Ref. No. 201505020
Petition No. 581

**REQUEST ENCROACHMENT
 (With Permanent Stairwell)
 INTO ST. ANTOINE
 AT 1200 ST. ANTOINE**

CITY OF DETROIT	
CITY ENGINEERING DEPARTMENT	
SURVEY BUREAU	
JOB NO.	01-01
DRWG. NO.	X 581

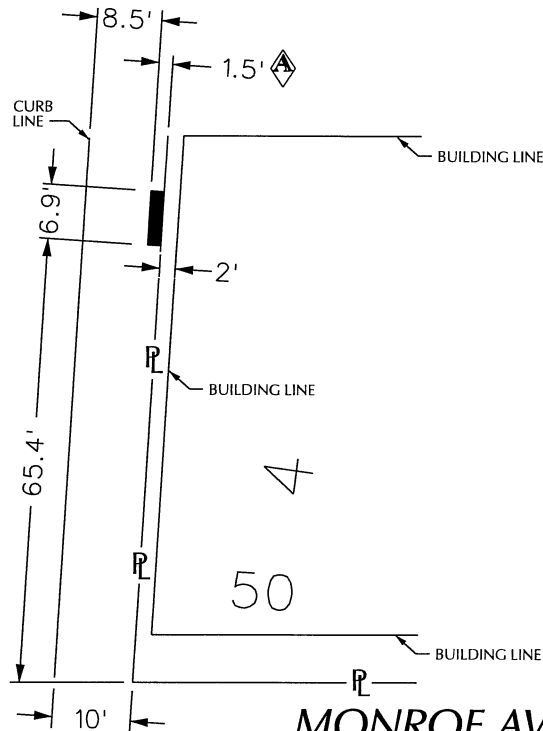
- () Not Involved.
- () Involved; but asking you to hold action on this petition until further notice.
- () Involved; the nature of our services, and the estimated costs of removing and/or rerouting such services are:
- (X) Involved; have no objection to the requested encroachment into St. Antoine at 1200 St. Antoine (with permanent stairwell) as shown on drawing no. x581 dated 04/01/2015 and revised on 6/22/2015 provided that the proposed encroachment shall provide for a minimum unobstructed sidewalk width of 8'5" for pedestrian use.

B					
A	REVISED, REDUCE THE ENCROACHMENT FROM 2.6' TO 1.5'. REQUESTED ON 6/18/2015.	WLW	KSM	KSM	6/22/15
DESCRIPTION					
REVISIONS					
DRAWN BY		CHECKED			
DATE		APPROVED			
04-01-15
